## 2021 Race Championship Series

### TOYOTA RACING SERIES Championship Technical Amendment (Schedule TRS)

#### Championship Amendment

Diagram 11.6

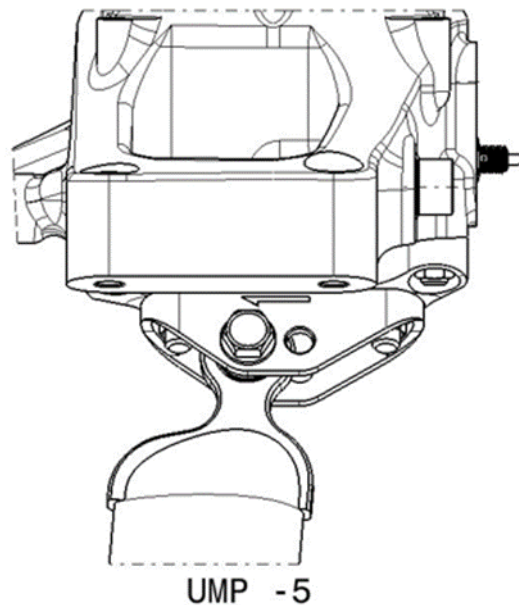
1. **Item One:** Replace existing 11.6 with the following:

- 1 Confirmation of agreed 2021 suspension configuration.

11.6 The only permitted UMP adjustment is the - 5 Position UMP configuration as defined by the diagram 11.6 below.

**Diagram 11.7**

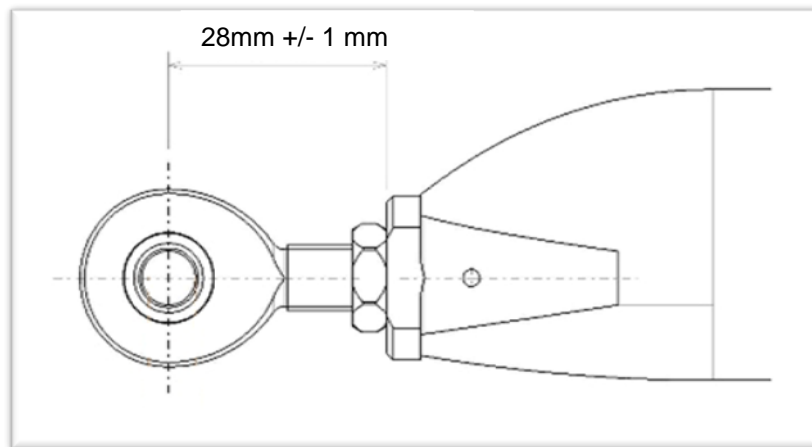
2. **Item Two:** replace existing 11.7 with the following:

1. *Confirmation of 2021 suspension Caster configuration.*

11.7 The caster of the front suspension must be set respecting the measurement defined by diagram 11.7 below.
